Draft proposal for an 08 series of amendments to Regulation No. 14 (Safety-belt anchorages)

Submitted by the expert from Australia

Figure 6
 ISOFIX Top tether anchorage location, ISOFIX zone - Side view

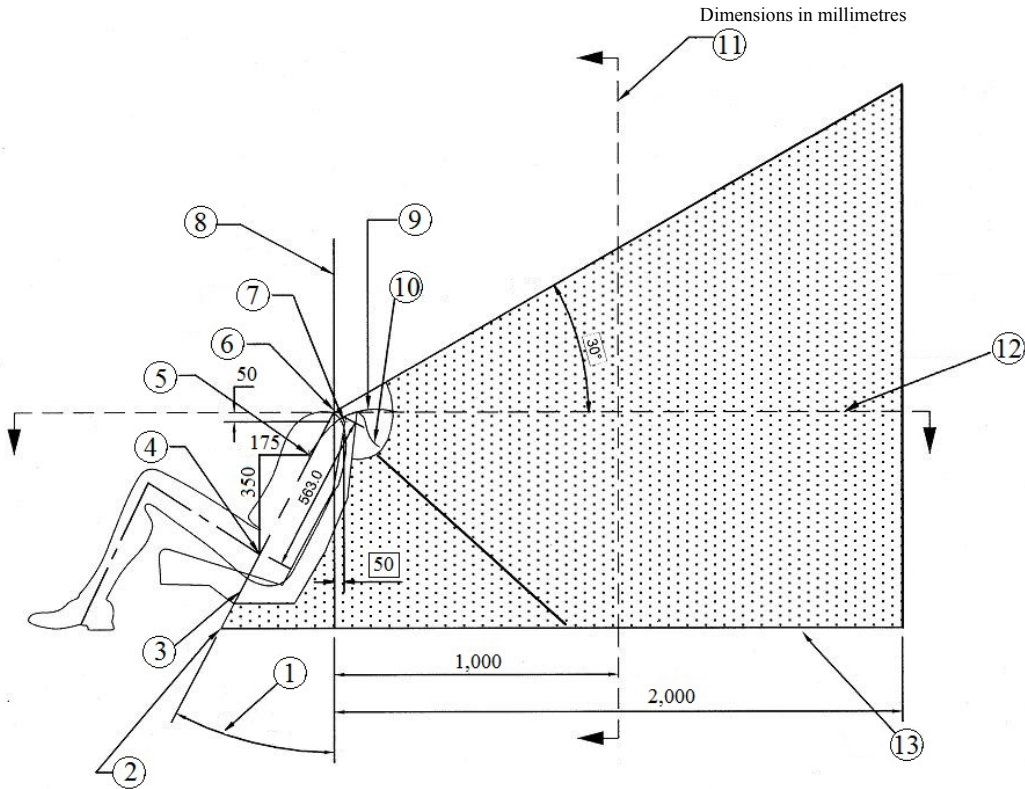
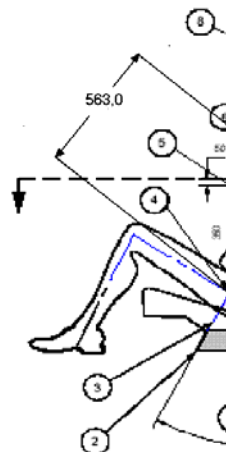
Comment [AUS70]: Changes proposed to angles in Figures 6 to 10 to guarantee a suitable level of top tether effectiveness and ensure that all ISOFIX top tether anchorages are compatible with top tether equipped child restraints mounted in combination with a safety belt or flexible lower connectors. To achieve this the ISOFIX top tether anchorage location ISOFIX zone should be harmonized with the corresponding requirements in FMVSS 225.

Figure 11
 Alternative method of locating the **ISOFIX** top tether anchorage using the "ISO/F2"
 (B) fixture, ISOFIX zone - side, top and rear views

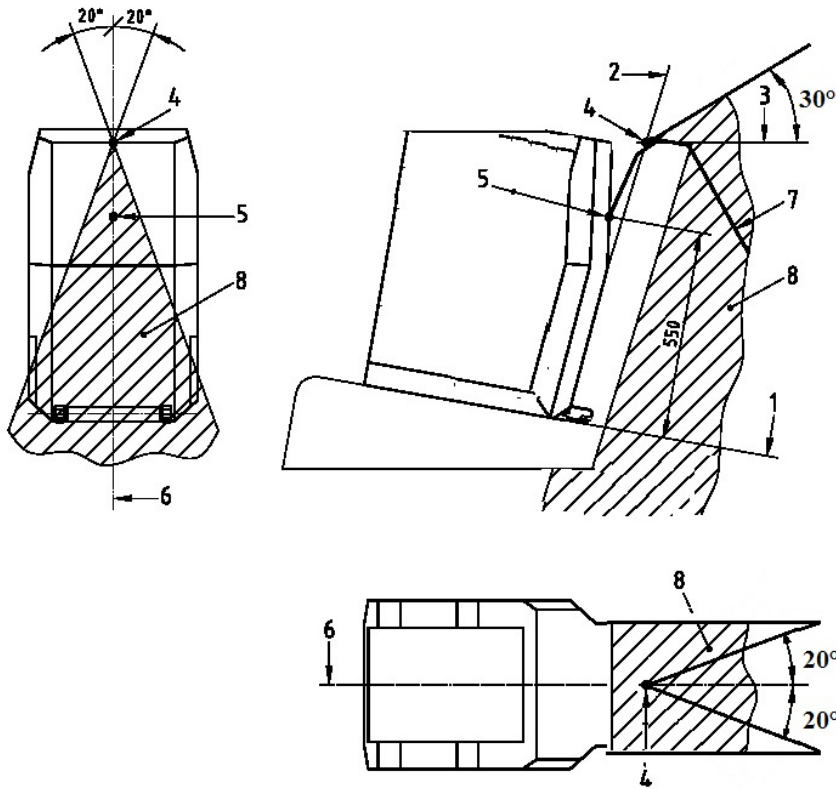
Comment [AUS71]: Changes proposed (as per Figures 6 to 10) to angles to guarantee a suitable level of top tether effectiveness and ensure that all ISOFIX top tether anchorages are compatible with top tether equipped child restraints mounted in combination with a safety belt or flexible lower connectors.

In the top view, at the reference point 4 (Annex 9, Figure 11), a maximum angle of 40° extending rearward and laterally and in the rear view, a maximum angle of 40° defines 2 volumes which limit the anchorage zone for the ISOFIX top tether.
